**COWBRIDGE COMP, ABERTHIN ROAD
BATS & LIGHTING**

Further to receipt of comments from the NRW (02 March 2021), please see the Site Lighting Plan (Drawing no: 319/2/E1) and amended bat house plan (Drawing no: 3703/PA/230 Rev A). NRW raised two main queries in their response of 02 March 2021 relating to the detail of the mitigation strategy and the lighting plan.

Proposed Bat Roost

Drawing No.
3703 / PA / 230

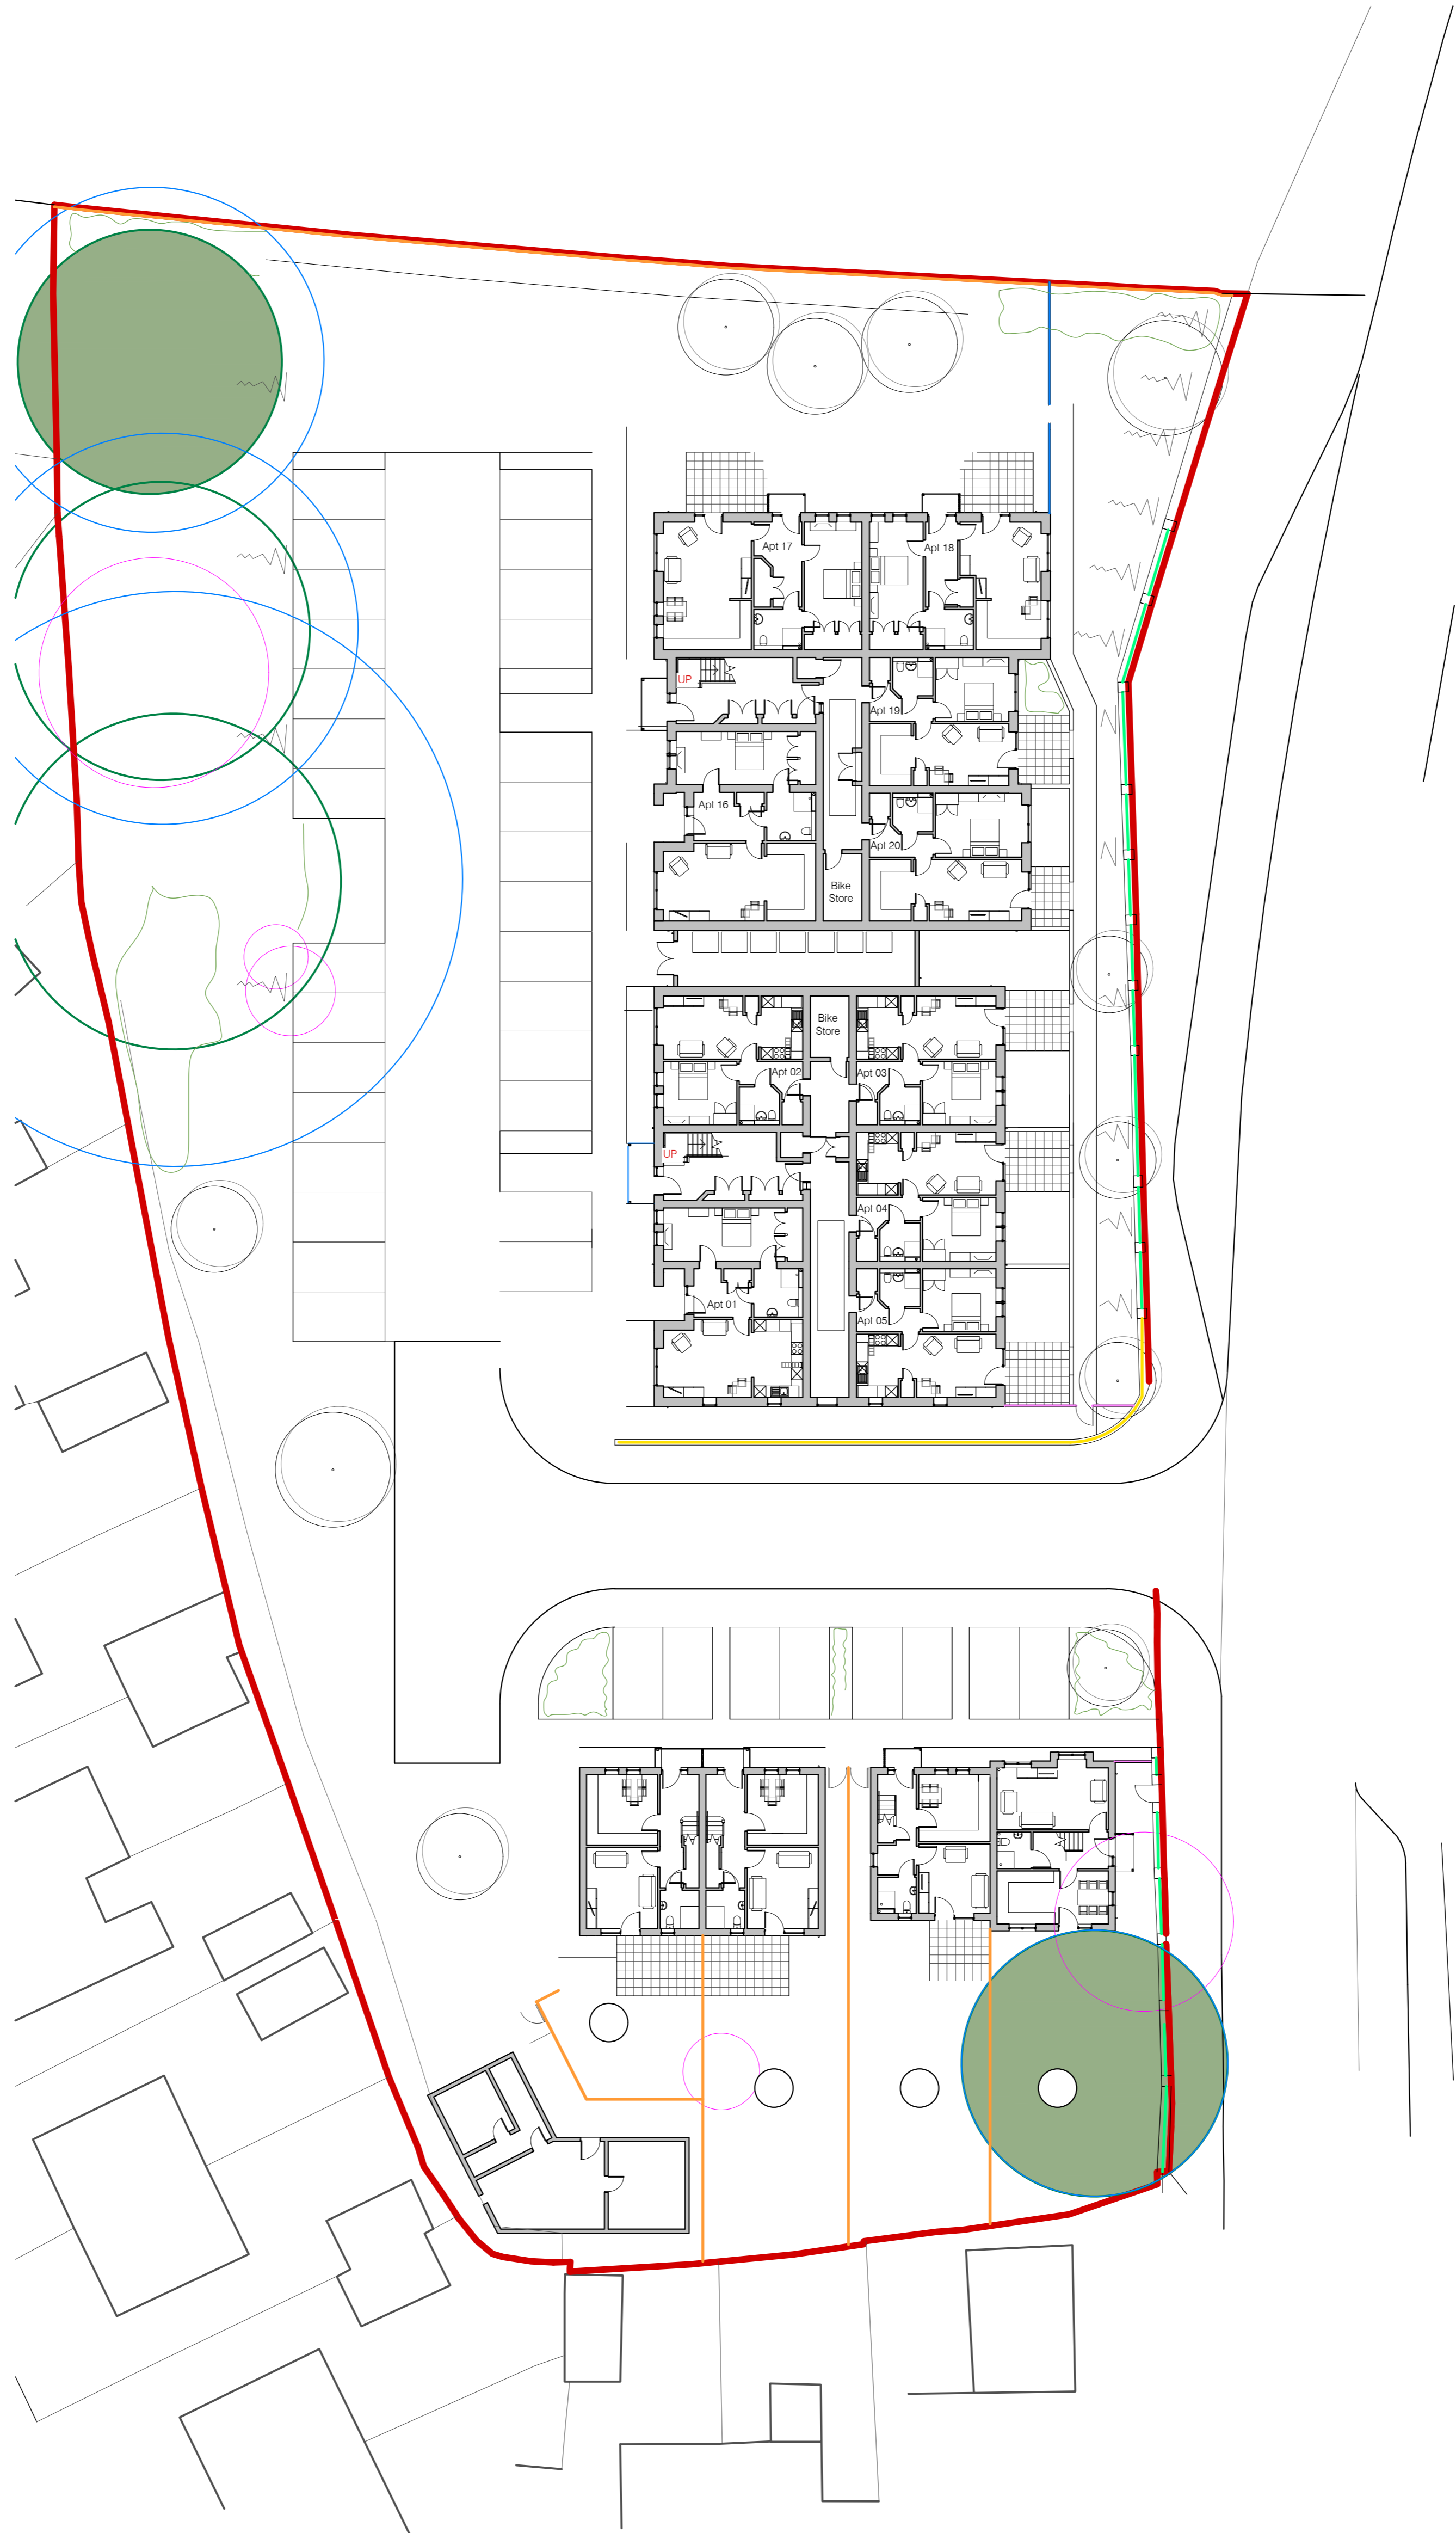
'A lighting and landscaping plan would need to be submitted with a planning application. This should look to reduce lighting over the site as a whole and avoid lighting completely in proximity to the bat house and the boundaries of the site, ensuring that a vegetated dark corridor would be maintained to the bat house which connects to the wider landscape. The plans should also include; the type of luminaire (including the exact specification), the location and height of the luminaire.'

A revised lighting plan has been produced by Tamlite Ltd. (Drawing no: 319/2/E1) to address these comments. A commitment has been made that:

- All external lights shall be 100% downward directional luminaires
- External lights to be contractor controlled as follows – western boundary to be switched off between 8pm and 6am (April to September) and dimmed to 25% (Oct to March).
- All other external lighting to be controlled via PIR and timer (set to 1min max).

With the adoption of these measures, the enclosed lighting plan demonstrates that a dark corridor can be maintained along the western boundary of the site, providing connectivity between the proposed bat house and the immediate local area. The lux plots illustrate that light reflected at ground level up to the red line boundary is around 1.0 lux, reducing further west. However it should be noted that the bollard lights are 1m high and throw light down and as such there would be virtually no lux level increase above a height of 1m. During the April – September period, these lights would be switched off and dimmed to 25% (i.e. a 75% reduction) from October to March thereby further reducing any risk of light spill and maintaining the dark corridor.

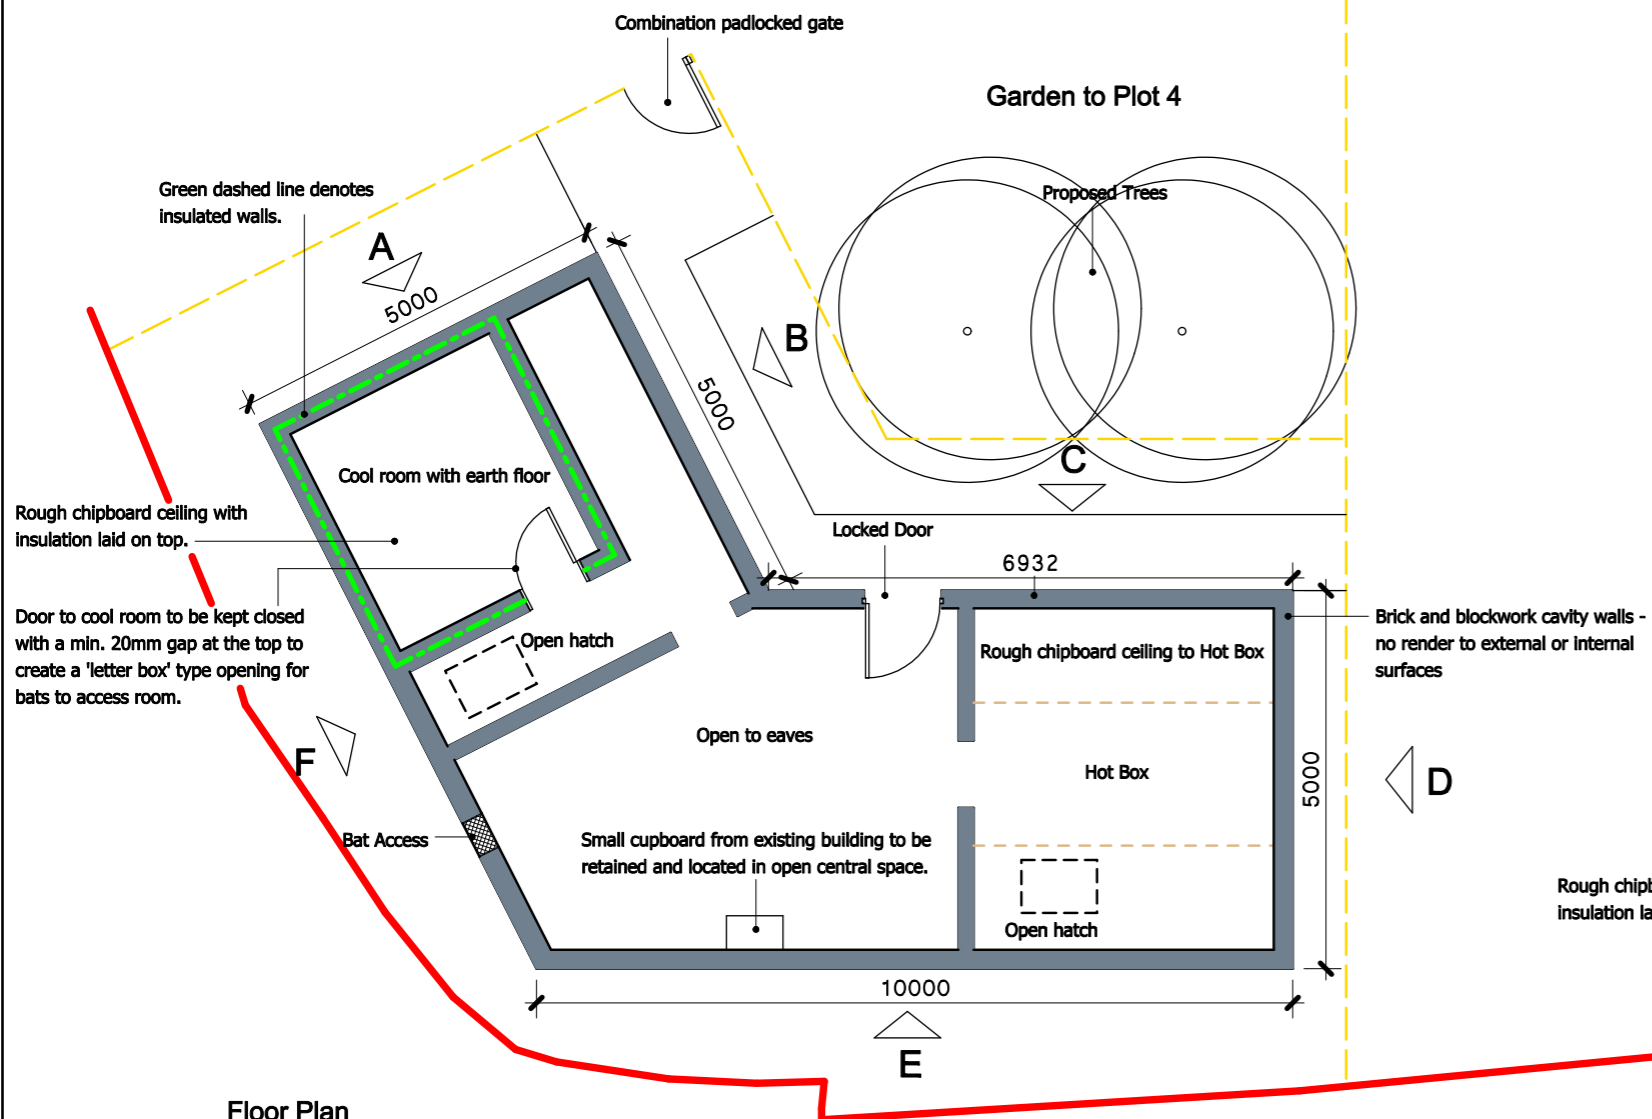
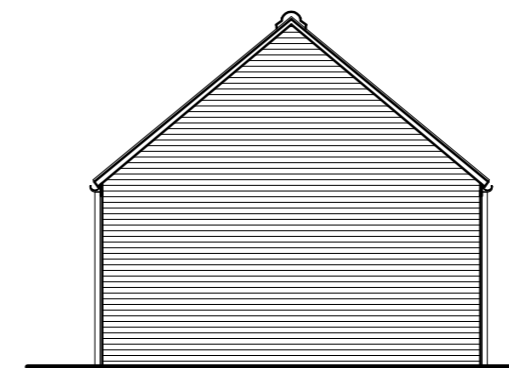
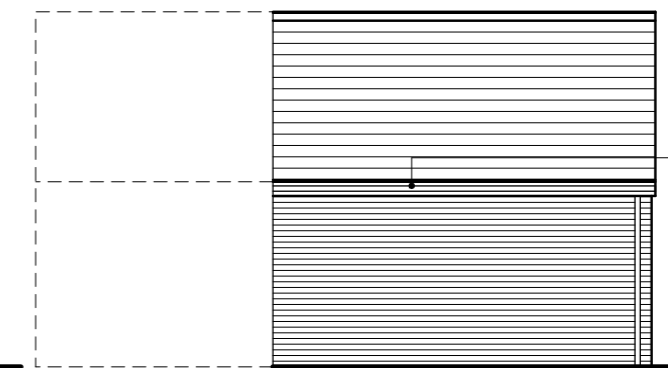
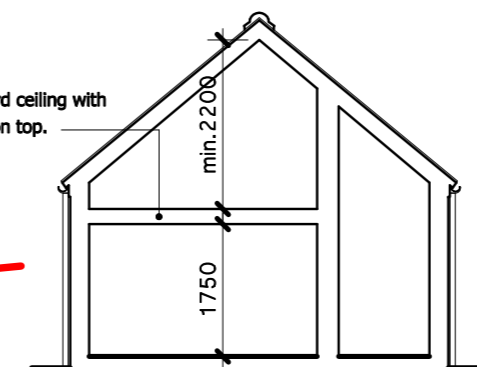
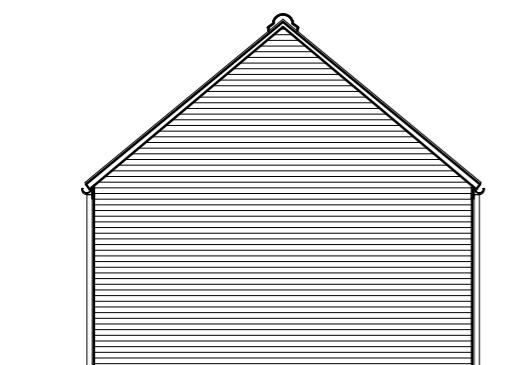
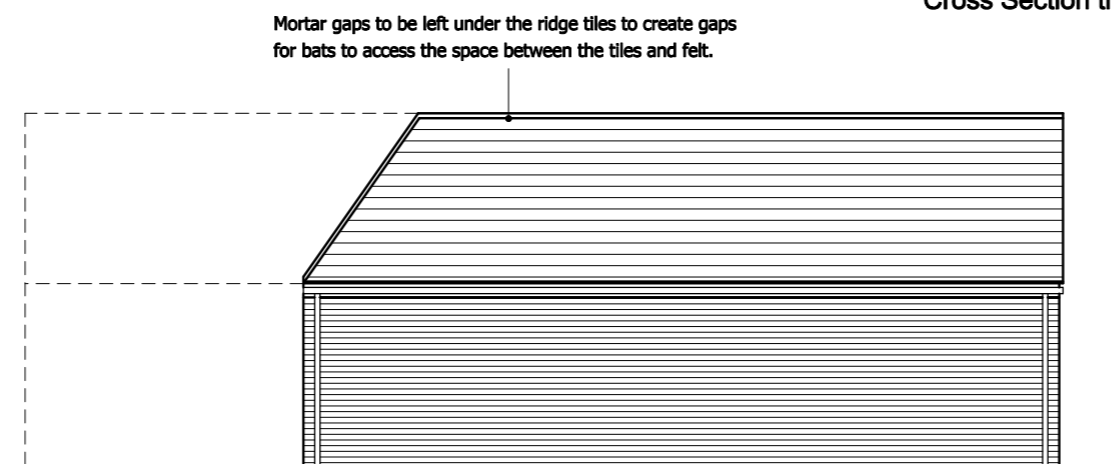
...a detailed mitigation strategy would need to be submitted upfront in support of any planning permission sought. Mitigation should be appropriate and proportionate to the bat species and roost types on site.' A detailed mitigation strategy must include;

- o Details of the permanent bat house to be provided including; all dimensions of the bat house and volume of bat roost areas, details of bat access points, materials to be used (i.e. earth floors, double skin walls), internal structure, and human access points for monitoring, how the bat house sits within the surrounding landscape.*
- o Details of provisions for the long term maintenance and site security of the permanent bat house.*

Additional detail has been added to the detailed bat house plan (Drawing no: 3703/PA/230 Rev A) specifically the internal height of the ground floor and the roof space in the bat house and whether the walls are double skinned.

A Additional notes added to plan and cross section added.
